## Product Change Notice (PCN)

PCN Number: **PCN-0451088R-01**

Product(s) Affected: **PJ-040-SMT-TR**

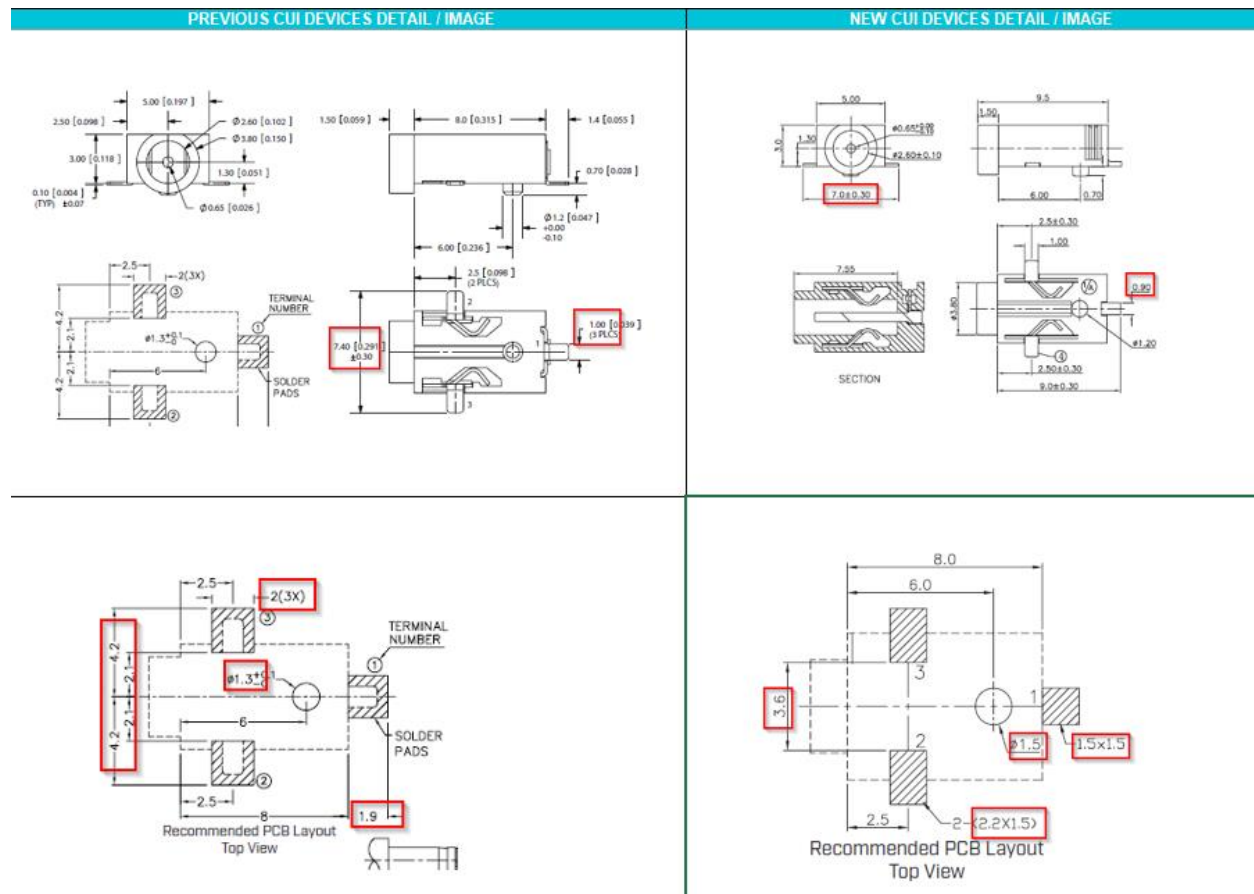
Description of Change: **Minor Housing and footprint differences. Material Change on the housing and terminals. See image Below**

PREVIOUS CUI DEVICES DETAIL / IMAGE	NEW CUI DEVICES DETAIL / IMAGE																																				
 <p>MATING PLUG Jack Insertion Depth: 7.7mm</p>	 <p>MATING PLUG Jack Insertion Depth: 7.55 mm</p>																																				
<table border="1"> <thead> <tr> <th></th> <th>MATERIAL</th> <th>PLATING</th> </tr> </thead> <tbody> <tr> <td>center pin</td> <td>copper</td> <td>nickel</td> </tr> <tr> <td>terminal 1</td> <td>brass</td> <td>silver</td> </tr> <tr> <td>terminal 2</td> <td>copper alloy</td> <td>silver</td> </tr> <tr> <td>terminal 3</td> <td>copper alloy</td> <td>silver</td> </tr> <tr> <td>plastic</td> <td>PA6T or equivalent</td> <td></td> </tr> </tbody> </table>		MATERIAL	PLATING	center pin	copper	nickel	terminal 1	brass	silver	terminal 2	copper alloy	silver	terminal 3	copper alloy	silver	plastic	PA6T or equivalent		<table border="1"> <thead> <tr> <th>DESCRIPTION</th> <th>MATERIAL</th> <th>PLATING/COLOR</th> </tr> </thead> <tbody> <tr> <td>center pin</td> <td>bronze</td> <td>silver</td> </tr> <tr> <td>terminal 1</td> <td>bronze</td> <td>silver</td> </tr> <tr> <td>terminal 2</td> <td>SUS301 t=0.20 mm</td> <td>gold</td> </tr> <tr> <td>terminal 3</td> <td>SUS301 t=0.20 mm</td> <td>gold</td> </tr> <tr> <td>housing</td> <td>PA10T (UL94V-0)</td> <td>black</td> </tr> </tbody> </table>	DESCRIPTION	MATERIAL	PLATING/COLOR	center pin	bronze	silver	terminal 1	bronze	silver	terminal 2	SUS301 t=0.20 mm	gold	terminal 3	SUS301 t=0.20 mm	gold	housing	PA10T (UL94V-0)	black

MATERIAL	PLATING																																			
center pin	copper	nickel																																			
terminal 1	brass	silver																																			
terminal 2	copper alloy	silver																																			
terminal 3	copper alloy	silver																																			
plastic	PA6T or equivalent																																				
DESCRIPTION	MATERIAL	PLATING/COLOR																																			
center pin	bronze	silver																																			
terminal 1	bronze	silver																																			
terminal 2	SUS301 t=0.20 mm	gold																																			
terminal 3	SUS301 t=0.20 mm	gold																																			
housing	PA10T (UL94V-0)	black
